MIL-P-50562(PA)
Amendment 3
15 MARCH 1976
SUPERSEDING
Amendment 2
19 September 1975

MILITARY SPECIFICATION

PROJECTILE, 8 INCH, M424A1 LOADING ASSEMBLY

This amendment forms a part of Military Specification MIL-P-50562(MU), dated 3 November 1971.

FIGURE II

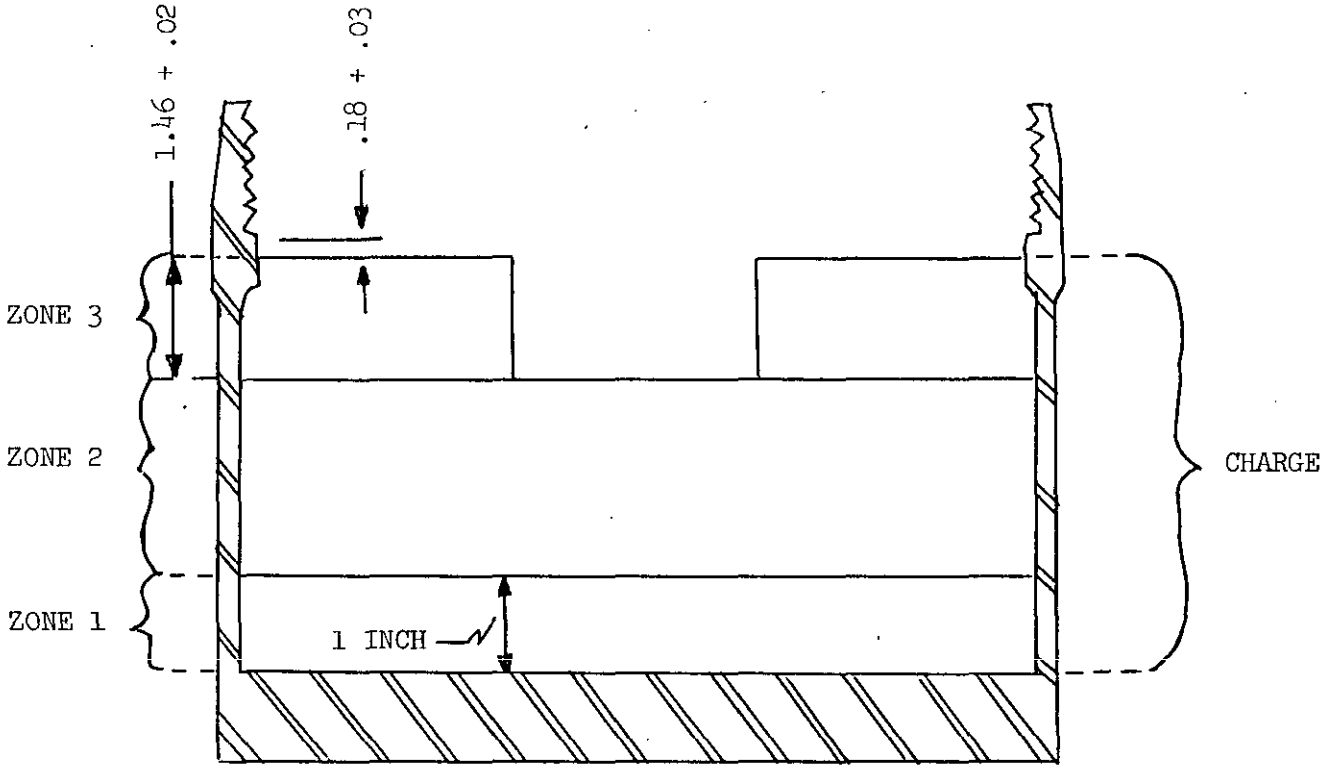
Page 2, delete Par 3.4 in its entirety and substitute the following:

"3.4 X-Ray examination. -

3.4.1 Zones. - For purposes of inspection and determination of cavities, cracks and etc, the charge shall be divided into Zone 1, Zone 2 and Zone 3 in accordance with Figure II and defined as follows:

A. Zone 1.

a. 3 vertical cracks maximum each not in excess of 1/16 inch width, shall be acceptable.

b. Maximum cavitation shall not exceed 1/32 square inch. However, no individual cavity shall exceed 1/8 x 1/4 inch projected area.

B. Zone 2.

a. Cracks in this zone shall not be considered for rejection purposes.

b. Total cavitation shall not exceed a total of 1 square inch.

C. Zone 3.

a. All explosive defects in this zone to be disregarded.
